# **Product Change Notification**

## **TE Connectivity**

**Product Change Notification:** PCN-23-189821

SR2M / V23047 force guided relays - product marking process change

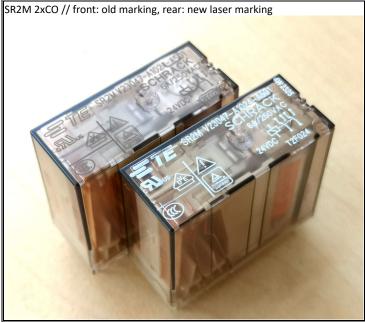
Dear customer, please be aware of an upcoming cosmetic change to the listed part numbers (not affecting the function of the product). As part of our continuous improvement of manufacturing processes regarding our environmental impact and sustainability, we will change our process of product marking from white-color pad printing to a more state-of-the-art laser marking process, much like TE is already doing on other clear-cover relays such as SR4, SR6 or RT. The content and arrangement of the information on the relay cover will not change.

Laser marking is a consistent and reliable state-of-the-art process, which generates no waste during marking changes and works without additional substances such as colors or cleaning chemicals, making it an overall more sustainable way of marking our product.
